PORTION OF SE QUARTER OF SEC 27, TWN 20 N, RGE. 4 E, W.M.
CITY OF PUYALLUP, PIERCE COUNTY, WASHINGTON

No.	Date	By	Ckd.	Appr.	Revision
3	10/03/24	DL	DL	JSG	RESPONSE TO CITY COMMENTS, DATED APRIL 12, 2024
2	03/05/24	DL	DL	JSG	RESPONSE TO CITY COMMENTS, DATED FEBRUARY 06, 2024

Title: COVER SHEET
CIVIL PLANS
FORTRESS - PUYALLUP

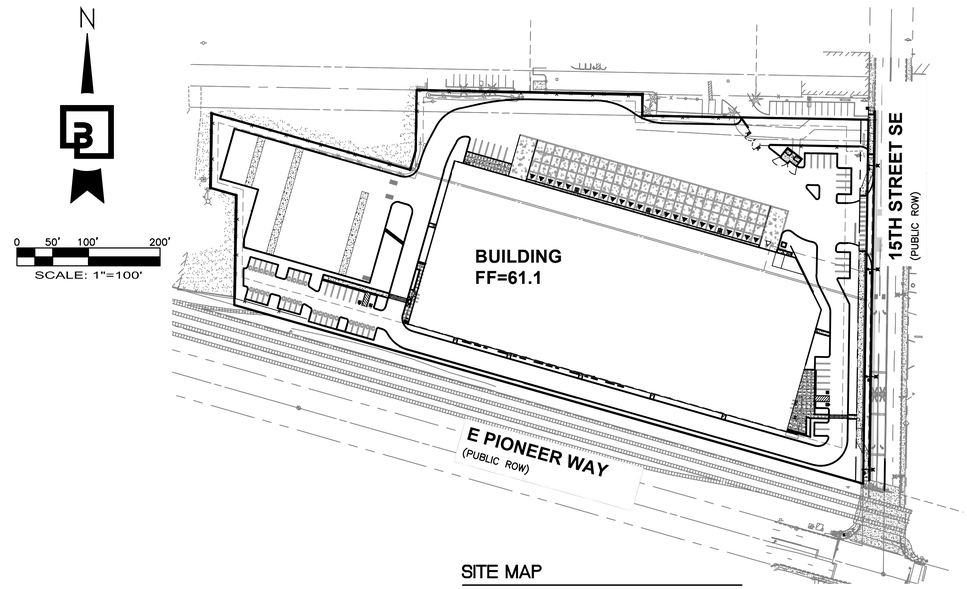
Replace "Water Division" with "Public Works" [civils, 1]

Title: **CIVIL TESC AND DEMOLITION PLAN**

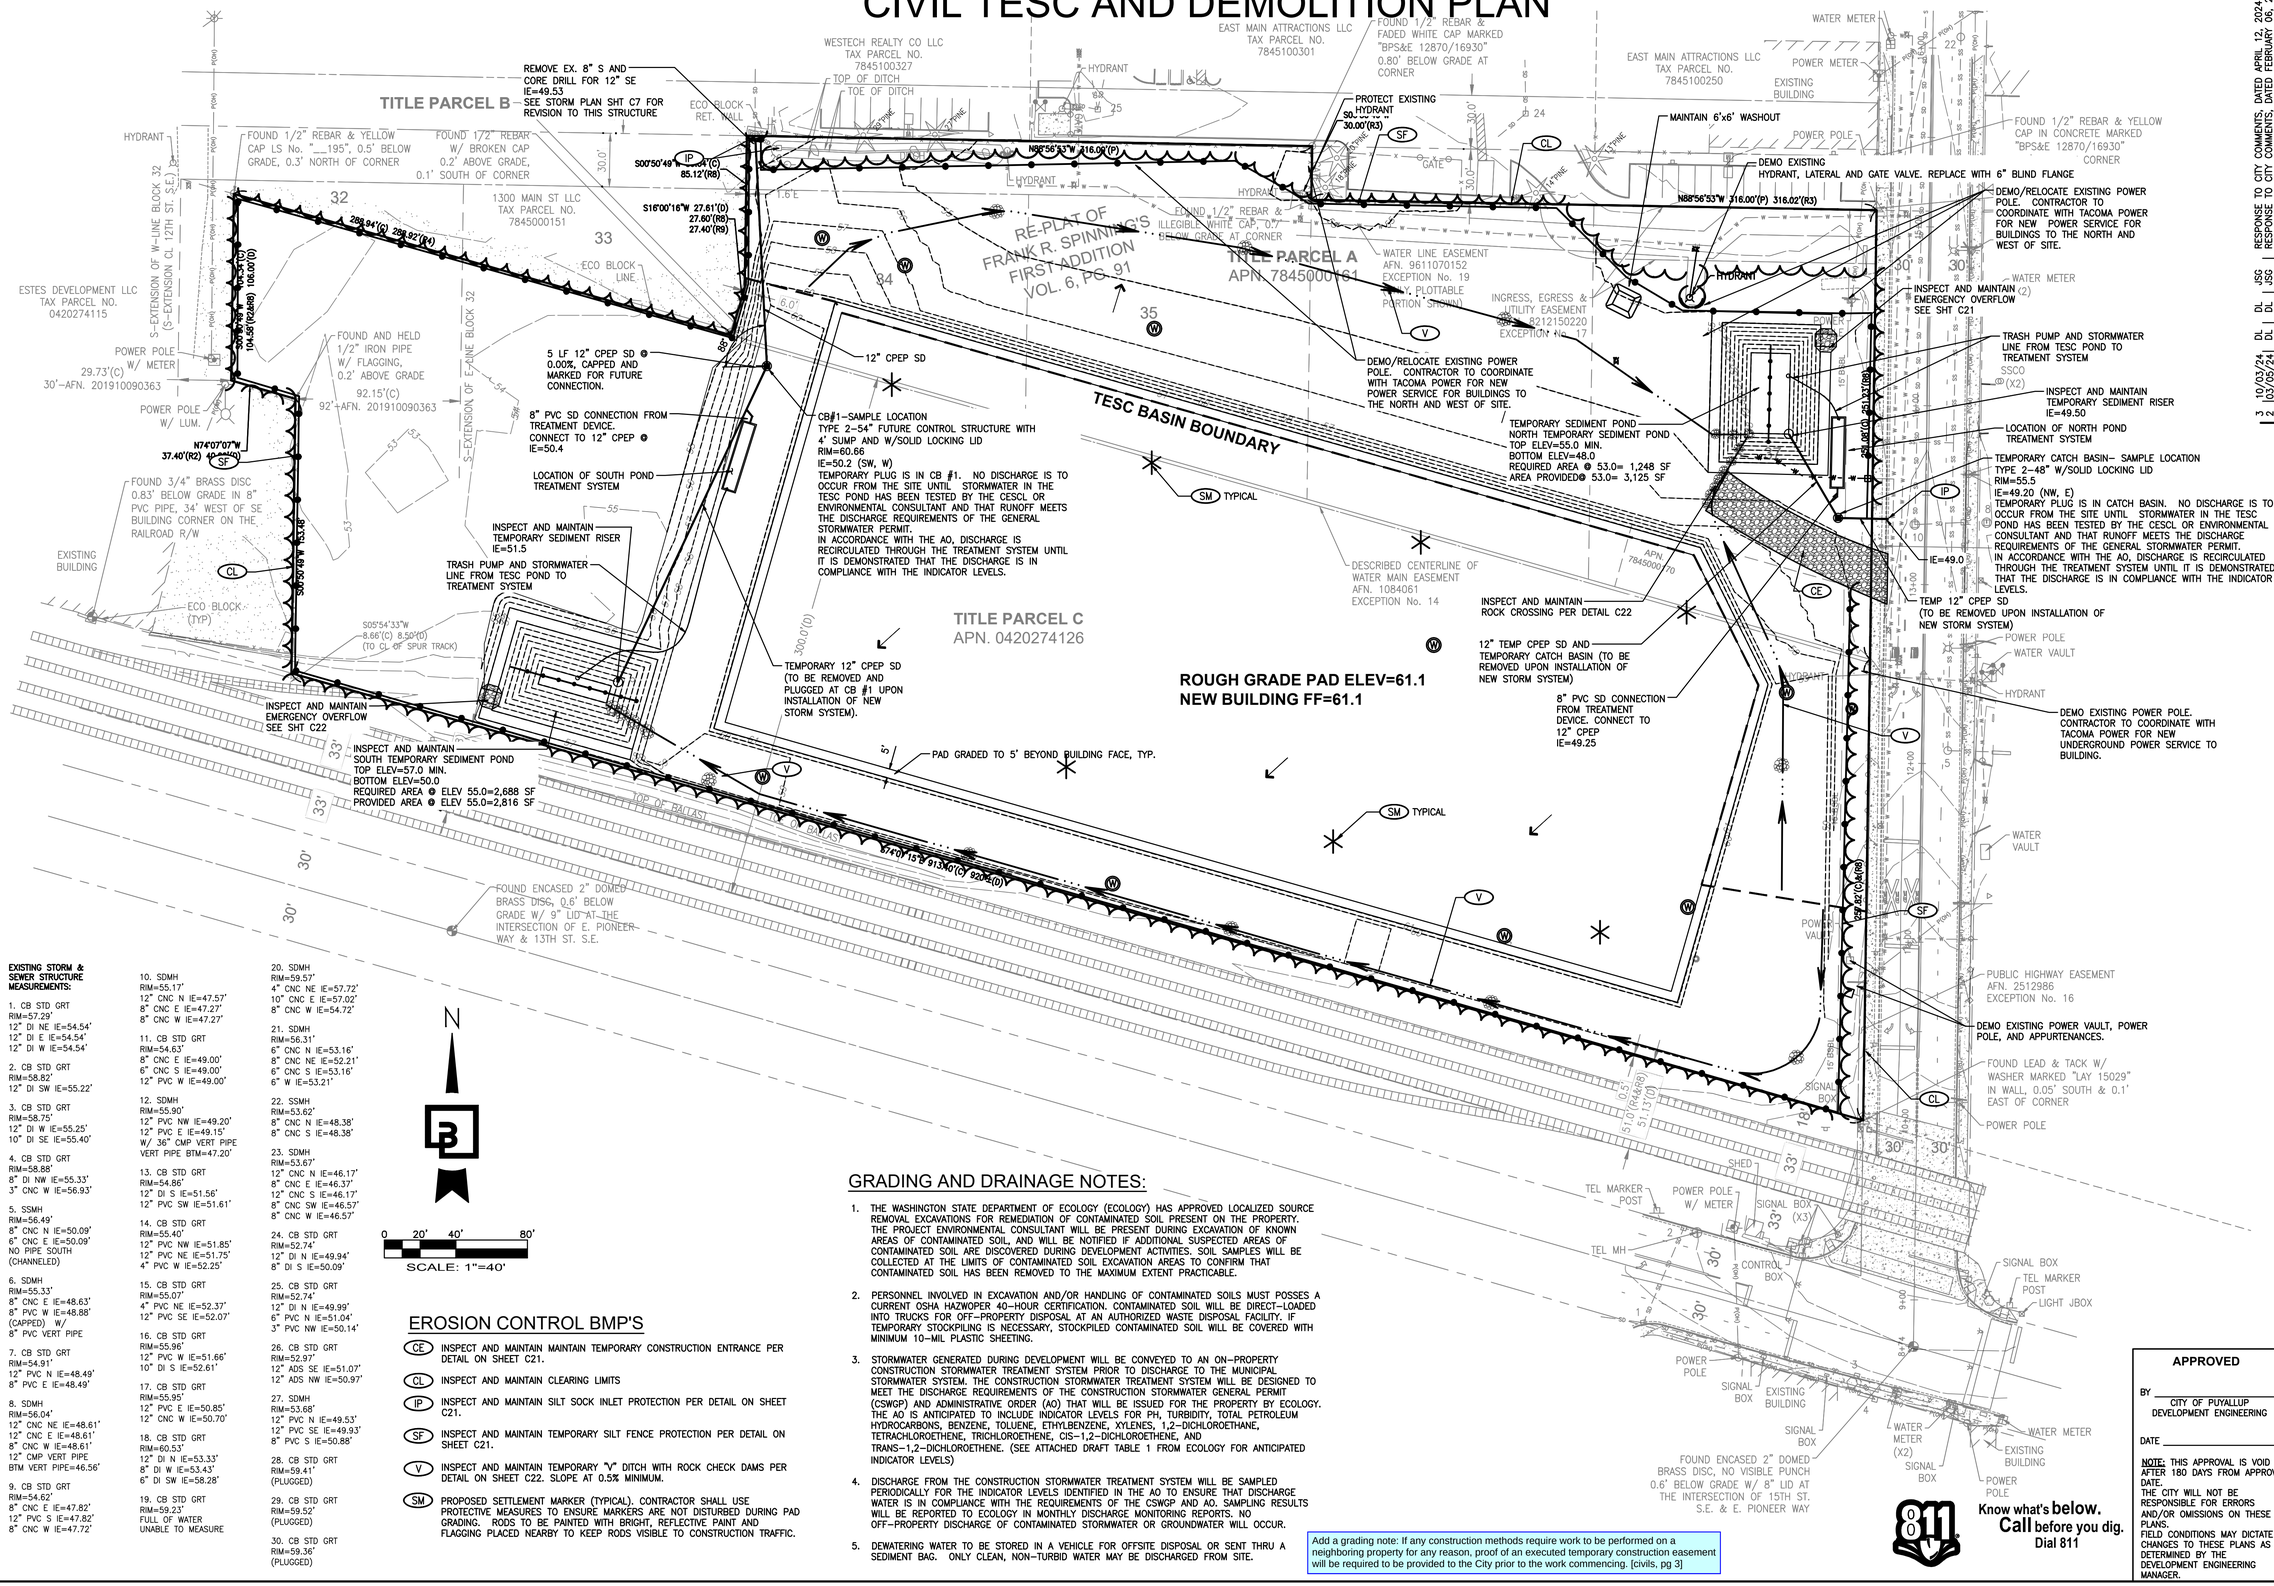
Add a grading note: If any construction methods require work to be performed on a neighboring property for any reason, proof of an executed temporary construction easement will be required to be provided to the City prior to the work commencing. [civils, pg 3]

Title: **SITE PLAN**

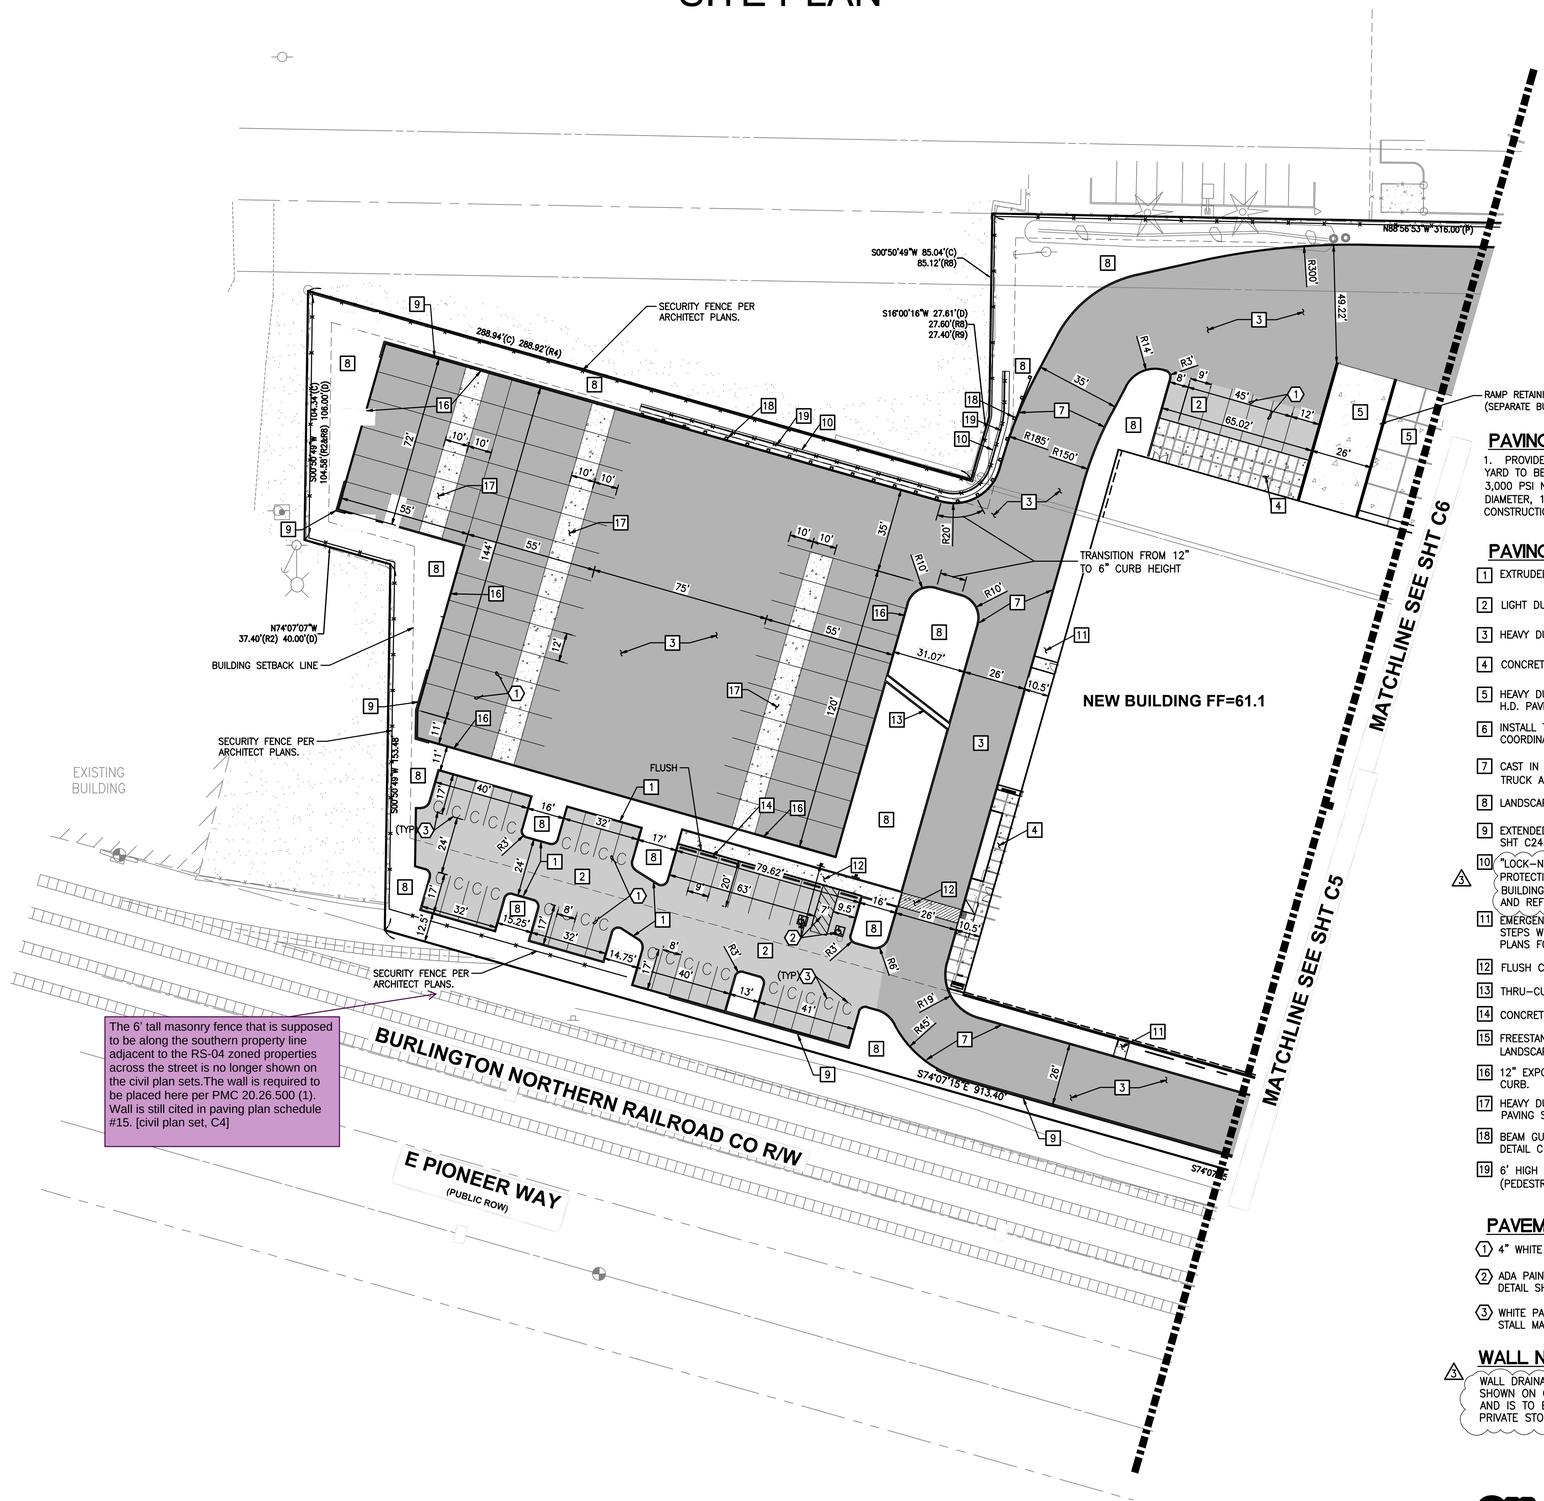
The 6' tall masonry fence that is supposed to be along the southern property line adjacent to the RS-04 zoned properties across the street is no longer shown on the civil plan sets.The wall is required to be placed here per PMC 20.26.500 (1). Wall is still cited in paving plan schedule #15. [civil plan set, C4]

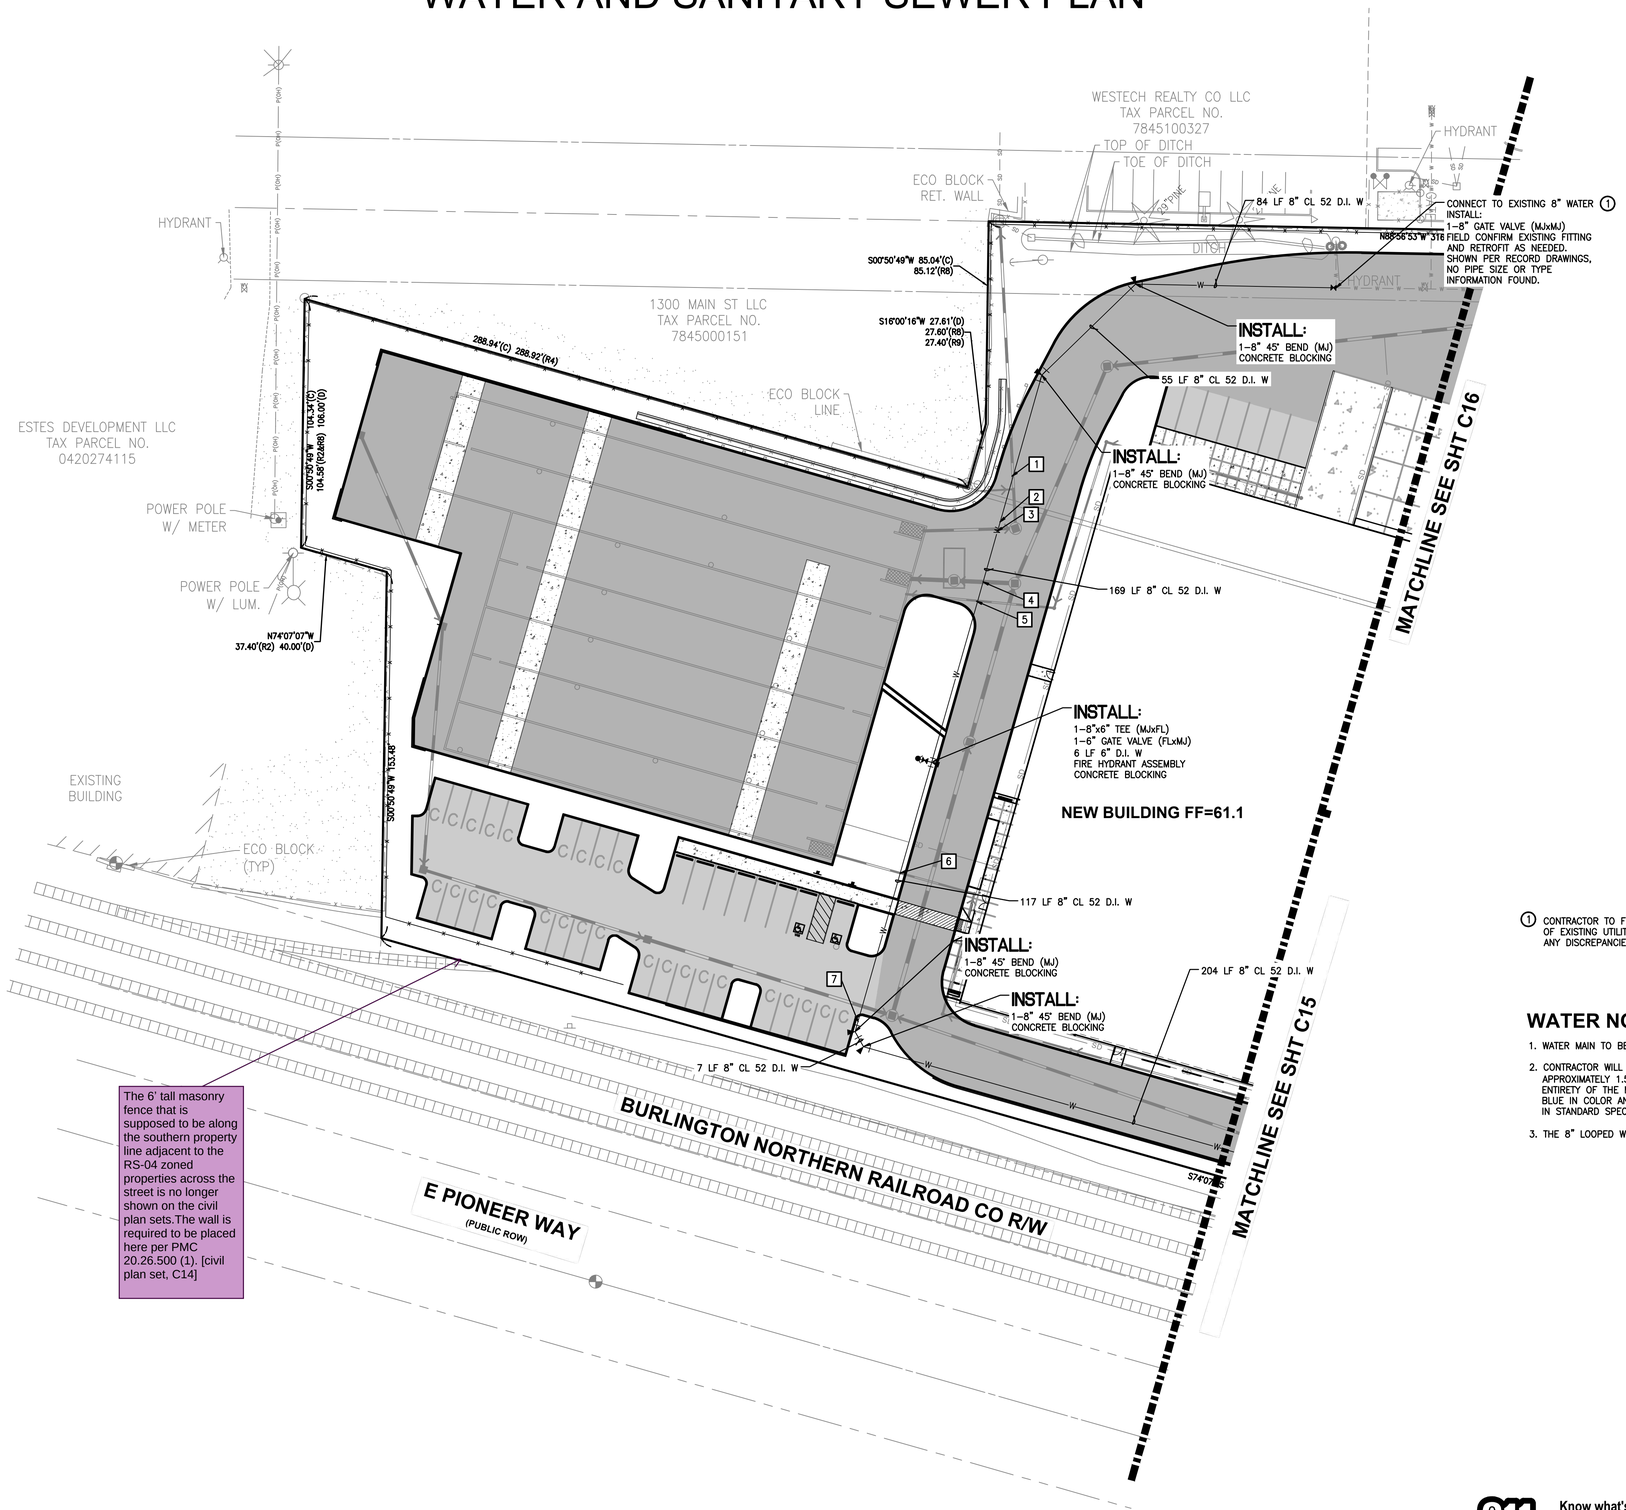
The 6' tall masonry fence that is supposed to be along the southern property line adjacent to the RS-04 zoned properties across the street is no longer shown on the civil plan sets.The wall is required to be placed here per PMC 20.26.500 (1). [civil plan set, C14]
